TITLE: CHANGE OF ZONE NO. 16024
B-3 Commercial and R-6 Residential to B-3 - Leighton Mixed-Use Planned Unit Development (North 48th Street and Leighton Avenue)

LINCOLN/LANCASTER COUNTY PLANNING STAFF REPORT

PROJECT #: Change of Zone No. 16024 - Planned Unit Development (PUD)

LEIGHTON MIXED USE
PLANNED UNIT DEVELOPMENT
48TH AND LEIGHTON AVENUE
PHASE 1 SITE PLAN

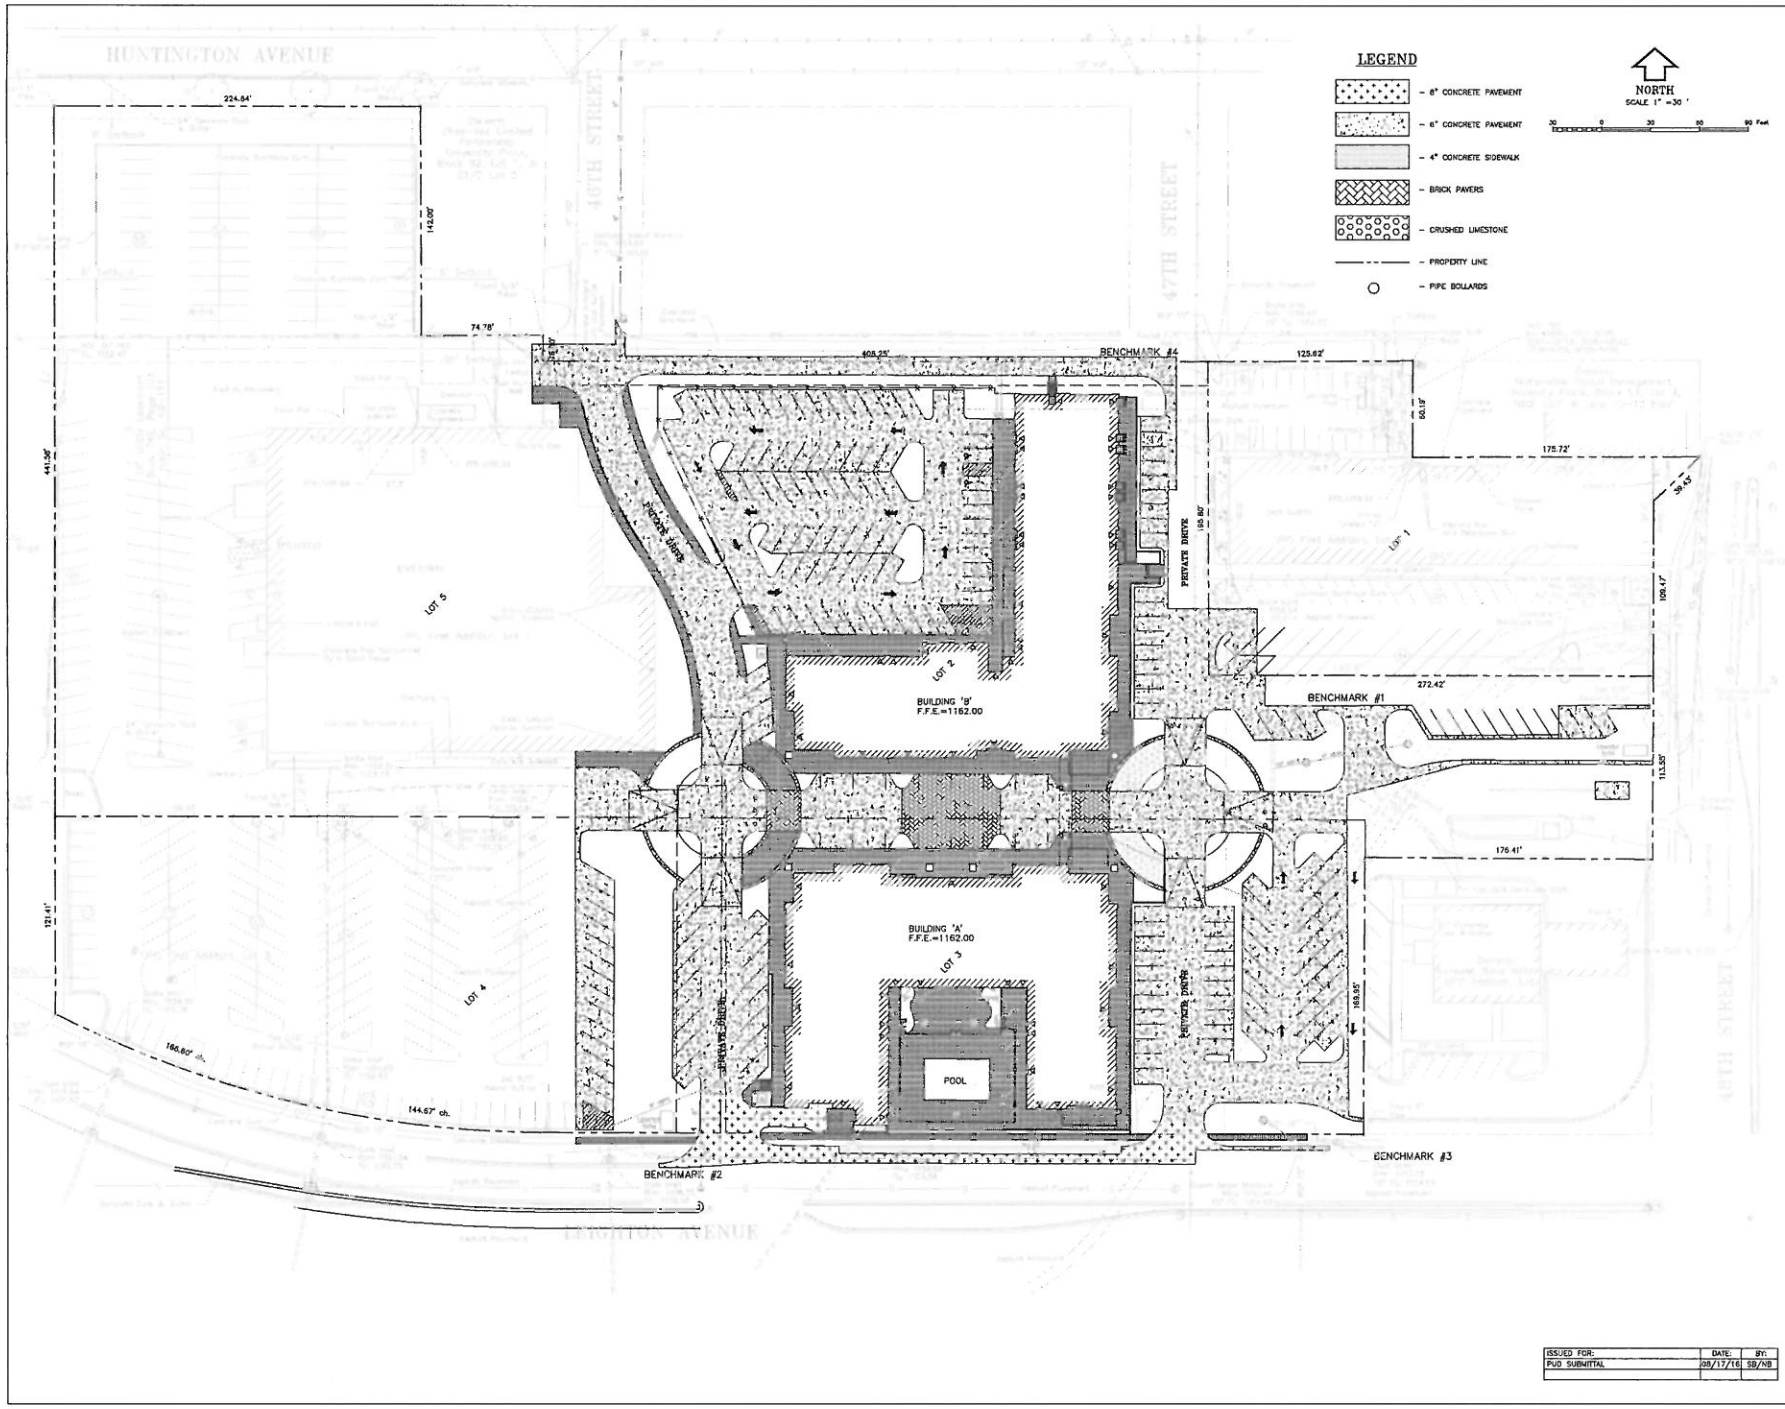
2.1 Remove side, front, and rear setback lines and add building envelopes with dimensions from property lines. Building envelopes for Phase One shall roughly approximate building footprint shown on plan. The north building envelope shall be no closer than 19 feet from the north property line. The south building envelope may be zero feet from the south property line.

2.2 Revise note regarding height to show maximum height of both the north building envelope and the south building envelope ~~at 60 feet and maximum height of south building envelope~~ at 75 feet subject to approval

2.5 For Waiver 3 remove reference "and any accessory".

2.6 Remove Waiver 2. Per 28.03.060©) the Director may approve the use of best management practices in lieu of detention to address storm water quality.

2.7 Show on site plan the area that is being re-zoned from R-6 to B-3 PUD, and add note that only parking and uses permitted by right in the R-6 district are permitted in that area.

2.8 Show new and existing sidewalk along Huntington Avenue and N 46th Street. New sidewalk is required north of the existing parking lot along Huntington Avenue and on one side of N 46th Street.

2.9 Add to Note 3:

"Street trees will be provided along Leighton Avenue, Huntington Avenue, and N 48th Street. Within any redeveloped parking area there shall be a minimum 8-foot green space for car overhang and landscaping. The redeveloped parking along Huntington Avenue shall have a minimum 20-foot green space."

2.11 Add note that buildings may be constructed anywhere within building envelope.

2.12 Change zoning ordinance reference in Note 11 to 27.63.680 and 27.63.685.

2.13 Move the Miscellaneous Notes section to General Notes.

2.14 Move the legend to Sheet 1 and delete Sheet 3 as it doesn't provide any additional information.

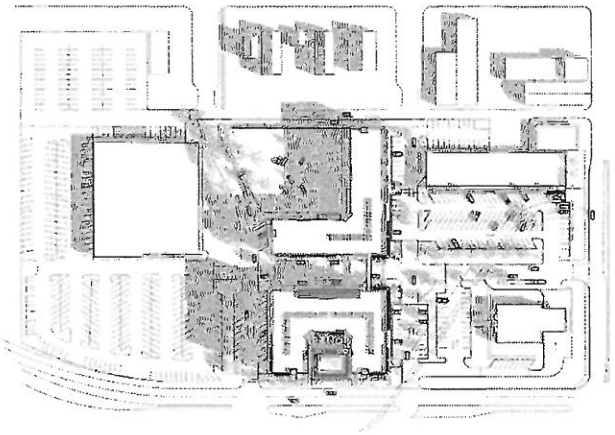
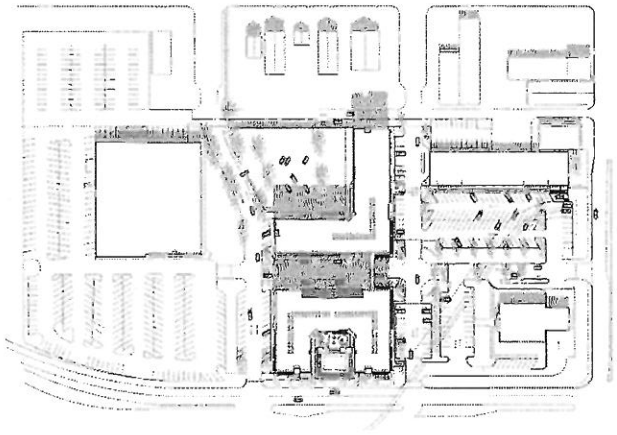
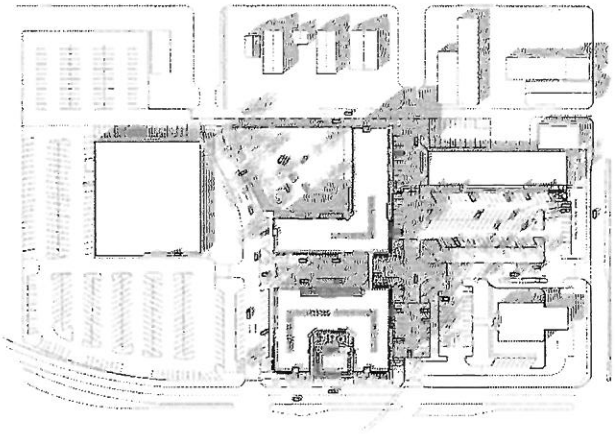
The plan shall be revised to show a height of 60 feet for the north building envelope and 75 feet for the south building envelope. The applicant provided a shadow study of the proposed north building and its impact on adjacent residential properties to the north. During peak times shadows may intrude into the rear yard of some residential properties, but no residential structures are directly impacted by shadows.
